# EXHIBIT K

## V. SATTUI HIBBARD RANCH VINEYARD CONVERSION Response to May 21<sup>st</sup>, 2019 Completeness Determination from Napa County #P19-00069-ECPA

**V. SATTUI HIBBARD RANCH VINEYARD CONVERSION**  
**Response to December 4<sup>th</sup>, 2019 Completeness Determination from Napa County**  
**#P19-00069-ECPA**

**Southern portion:**

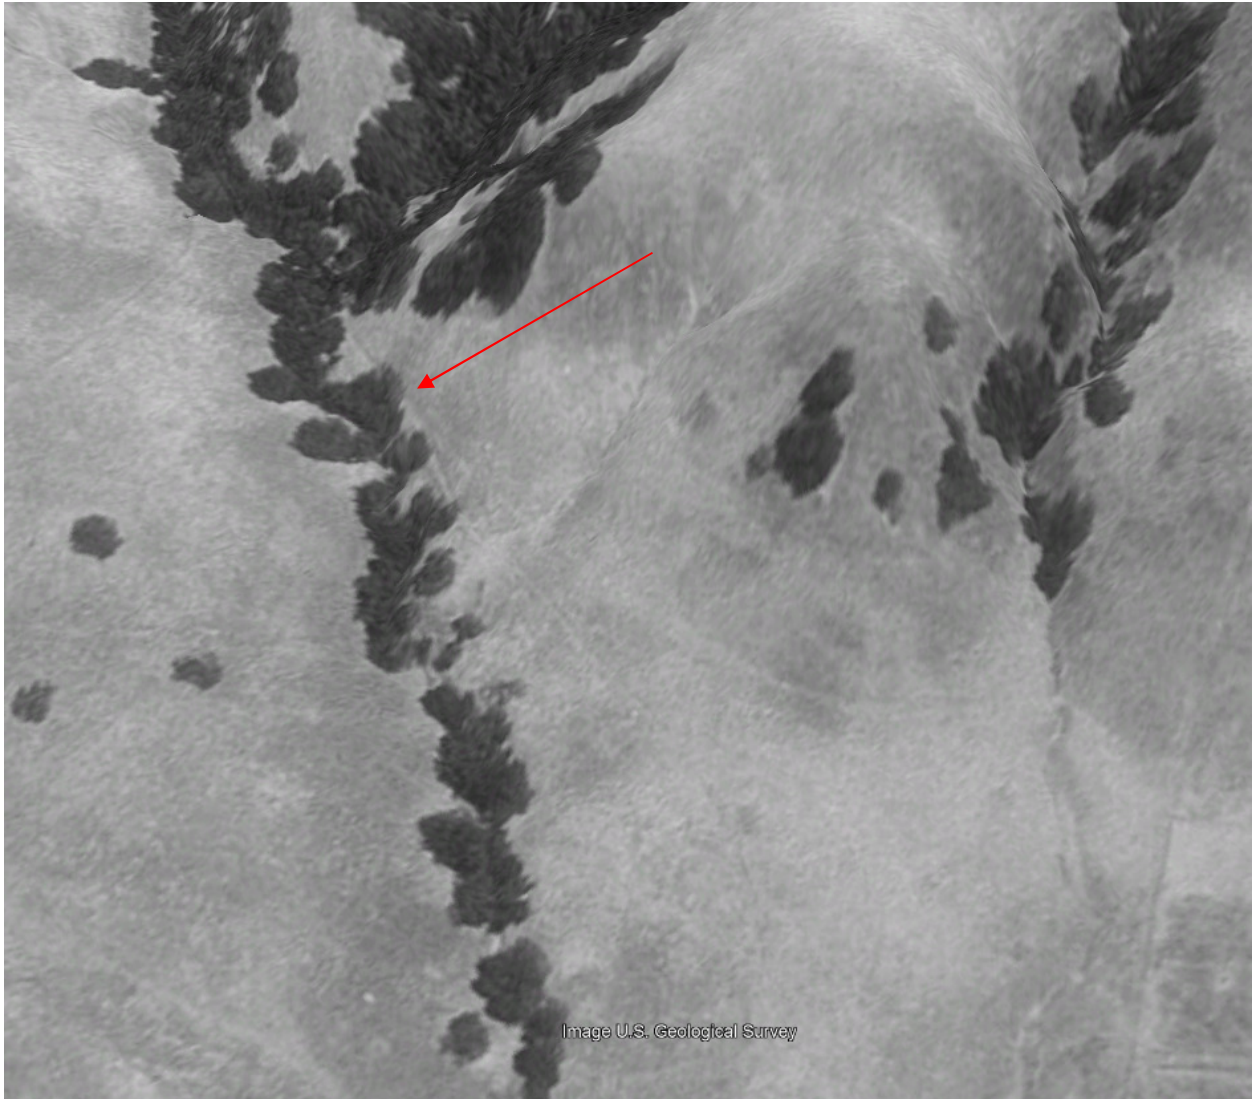
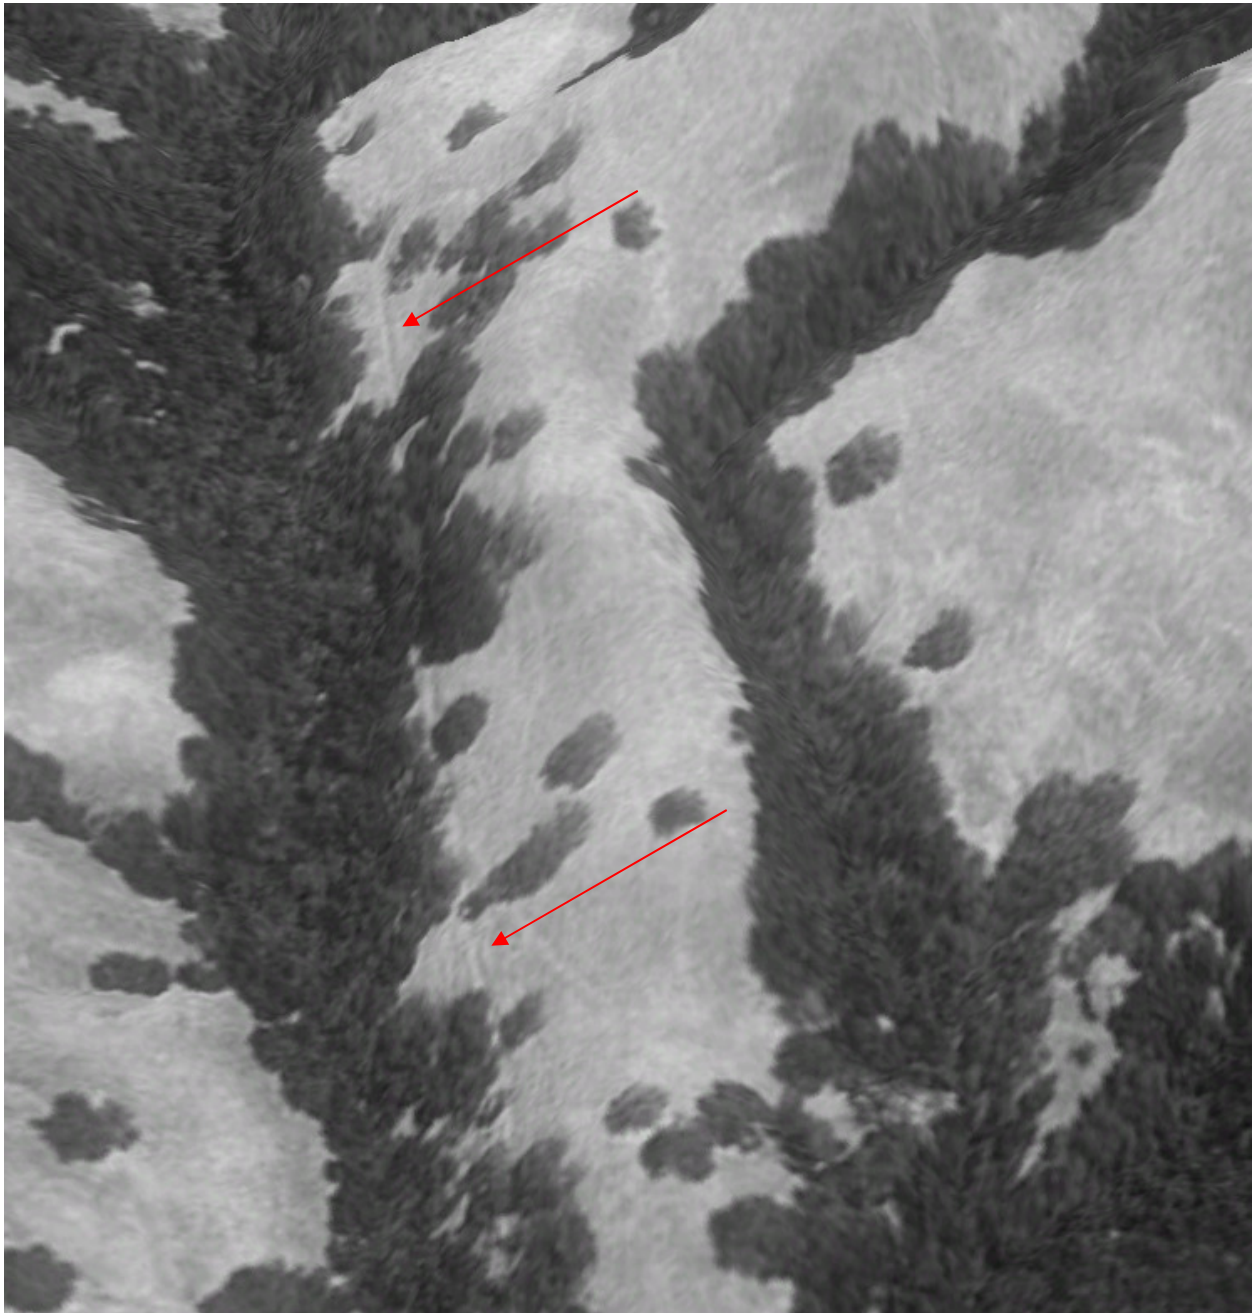
Based on review of #99230-ECPA for the property, historic aerial imagery interpretation, the site inspection, and consultation with the County Engineering Division, it is evident that existing roads/trails east of the blue-line tributary to Carneros Creek that are proposed to provide access to Vineyard Block Complexes 1, 7 and 8 appear to have been developed sometime after 2010. This is of particular concern for the roads or portions thereof located within required stream setbacks (such as between Vineyard Block 7C and existing vineyard to the south), and/or are located on sloped in excess of 30% (such as located between Vineyard Blocks 8A and 7D and in areas between Vineyard Block 7C and existing vineyard to the south). For portions of access roads that occur on slopes over 30% as show on County GIS Topographic Maps, provide slope calculations for the access prepared according to the ECPA Slope Determination Methodology for Roads (enclosed). Furthermore, it does not appear that there are existing road(s) available to access Vineyard Block 1.

Therefore, any grading or improvements to provide adequate access for vineyard development and operations, including assessment of roads that may have been developed without proper review and authorization, will need to be shown and detailed. Any new areas of earthmoving and associated tree removal to install and/or improve access roads will need to be included and accounted for in the project acreages and considered in the Soil Loss and Hydrologic modeling in that they are part of the project. Additionally, while it is indicated that irrigation lines will be located in existing roadways any trenching or earthmoving activity necessary to install irrigation lines within required stream setbacks may

**The road located to the east of the blue line stream is existing and has been since at least 1993. Anecdotally, the ranch manager reports that the road was used historically as part of the ongoing cattle operations on the property. As shown in the 1993 Google Earth image below, it can be seen that this is a main access point for vineyard blocks on the eastern portion of the property. No significant improvements are required to utilize this road, and as shown on the Site Plan, where the road enters the proposed vineyard block it will be treated as a vineyard avenue and will observe applicable County stream setbacks pursuant to Section 18.108.025, and will be straw mulched, vegetated, and have straw wattles installed per the ECP.**

2018 Napa County Aerial Photo

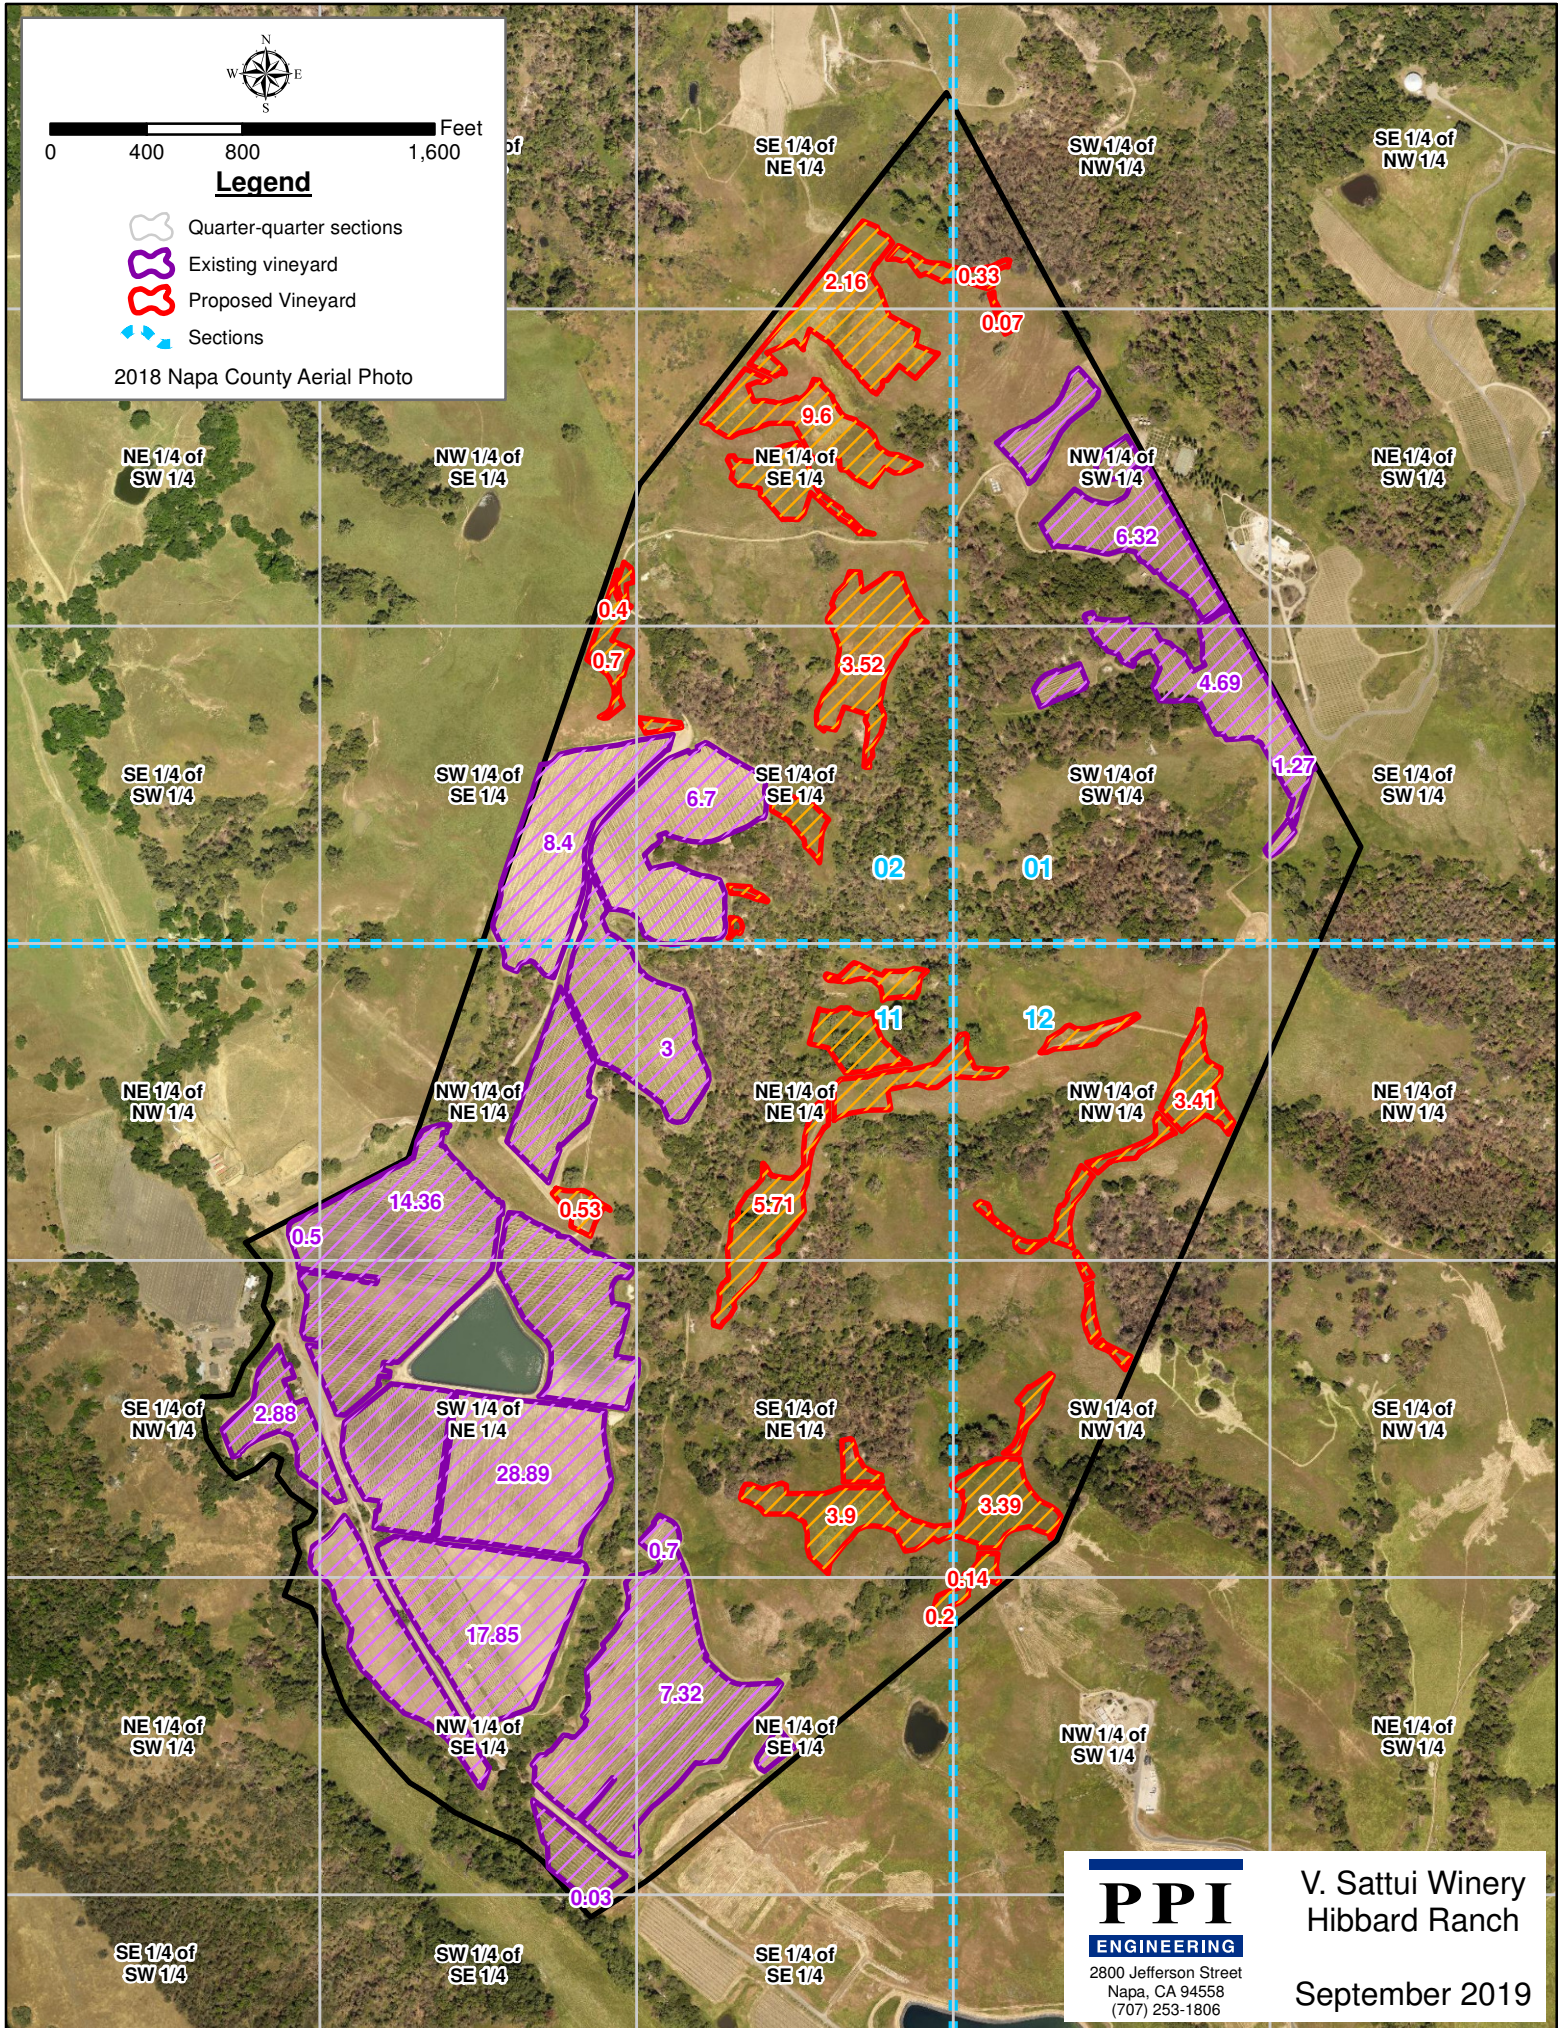
- a. Water Rights Place of Use (POU): Provide an exhibit/plan that shows existing and proposed vineyard within the parcel overlain by POUs and corresponding allowable acreage within each POU identified in Water Right Permit #20779. While it appears that the project may have been sited to observe Water Rights POU acreage limitations, this information is necessary to confirm that the proposed project in conjunction with existing vineyard is consistent with the property's Water Right Permit.

**The requested map showing the water rights POU, existing vineyard, and proposed vineyard has been included with this resubmittal package.**

**There are approximately 1.3 acres of proposed vineyard outside of the authorized POU for Water Right Permit #20079. The Applicant also has two existing onsite wells and water tanks that provide supplemental irrigation water as shown on the revised Site Plan. Accordingly, a Water Availability Analysis (WAA) has been prepared and is included with this resubmittal package to cover the use of groundwater for irrigation of 1.3 net acres.**
